Town of Enfield

BLACK OAK WIND FARM

**Supplemental Draft Environmental
Impact Statement**

Written Public Comments

Figure 8. Predicted Noise Levels at the Property Line near Turbine 6.

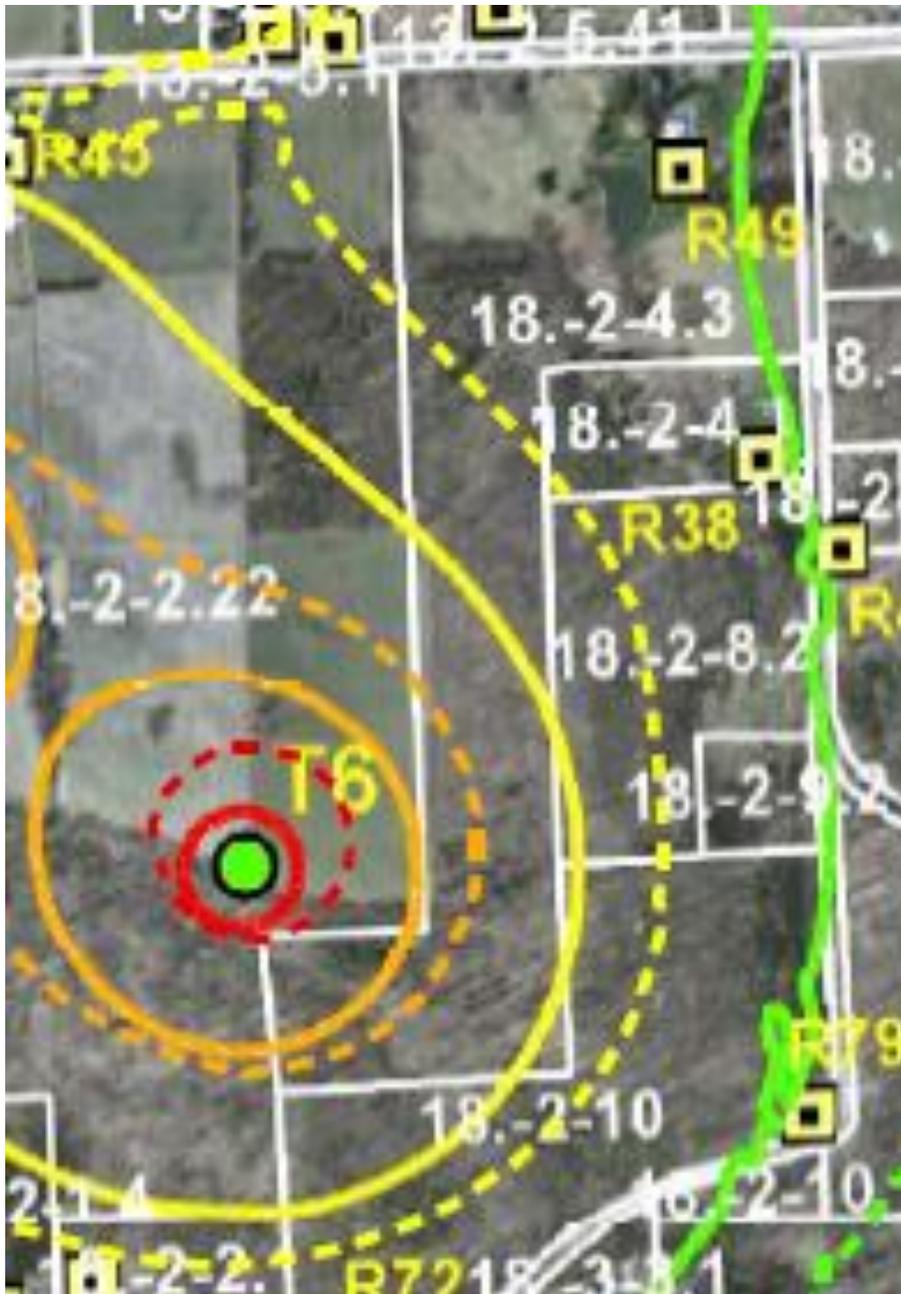
Figure 8 shows the predicted noise levels near Turbine 6. It is a composite of Figure 3 from Appendix H of the DSEIS (the dotted contour lines) and Figure 2 of Appendix T of the FEIS (the solid contour lines). According to the legends of these Figures, the red line corresponds to the 55 dBA level; the orange, to the 50 dBA level. The property lines are shown in white. The red dotted line representing 55 dBA from the DSEIS turbine configuration clearly touches the property line south of Turbine 6 in Figure 8. This location has an existing hiking trail nearby.

Figure 9. Predicted Noise Levels at the Property Line near Turbine C.

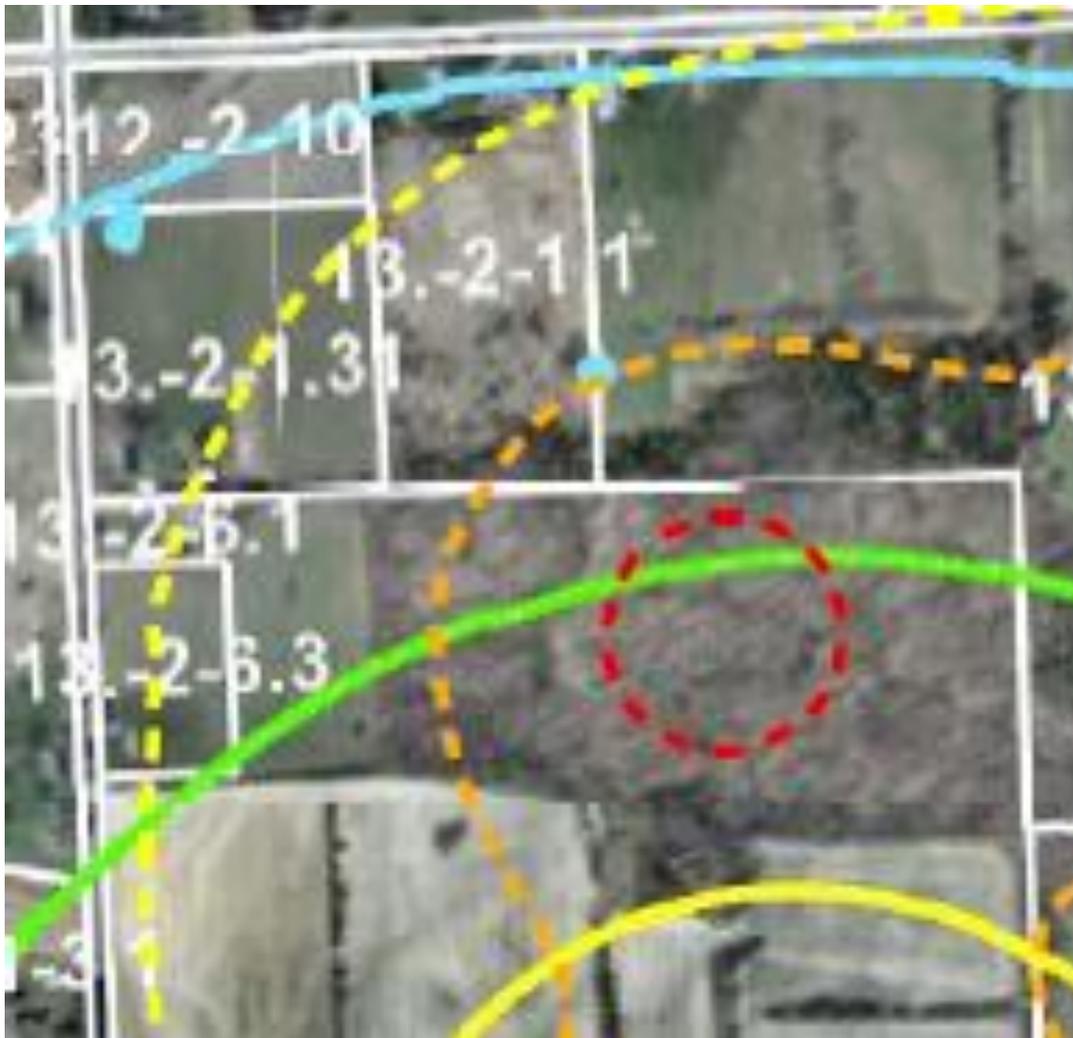
Figure 9 shows the predicted noise levels near Turbine C (not shown but inside the dashed red circle). It is a composite of Figure 3 from Appendix H of the DSEIS (the dotted contour lines) and Figure 2 of Appendix T of the FEIS (the solid contour lines). According to the legends of these Figures, the red line corresponds to the 55 dBA level; the orange, to the 50 dBA level. The property lines are shown in white. The orange dotted line representing 50 dBA from the DSEIS turbine configuration clearly crosses the property line northwest of Turbine C in Figure 9 marked 13.-2-1.1. This location is intended as a home site for the homeowners children, for which it would not be suitable if it were built.

Figure 10. Predicted Noise Levels at the Property Line near Turbine A.

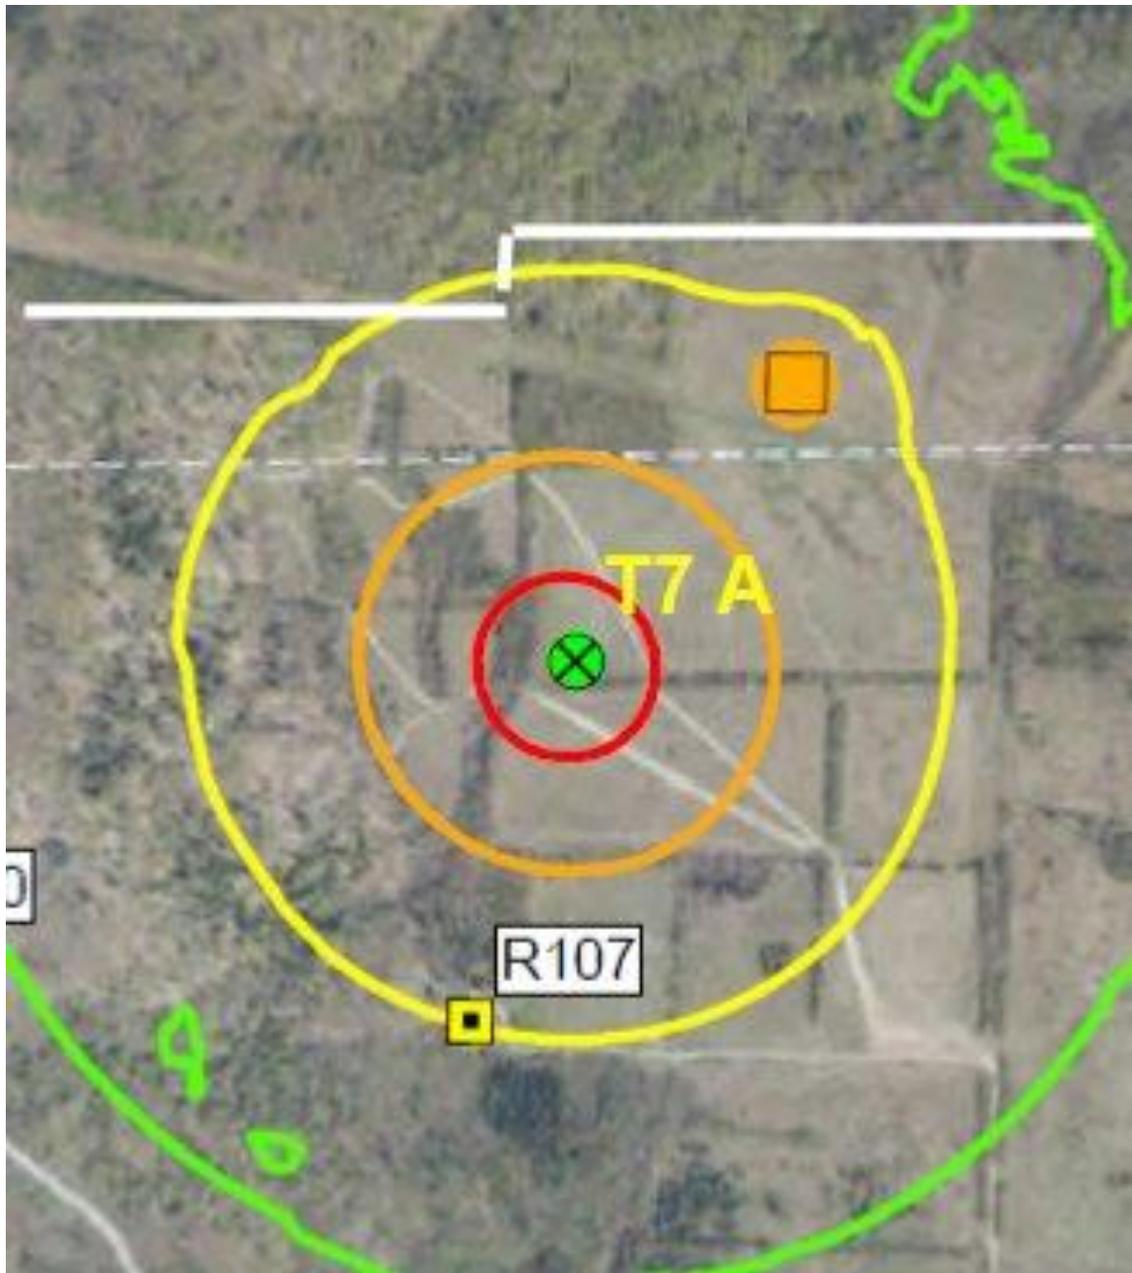
Figure 10 shows the predicted property line noise levels north of Turbine A from Figure 2 of the DSEIS Appendix H. The white property line of a non-participating neighbor has been added. From the figure one can see that the noise levels approach and exceed 45 dBA in this area. There is what the home owner calls his “second field” in this vicinity. It is a maintained grassy area with a structure.
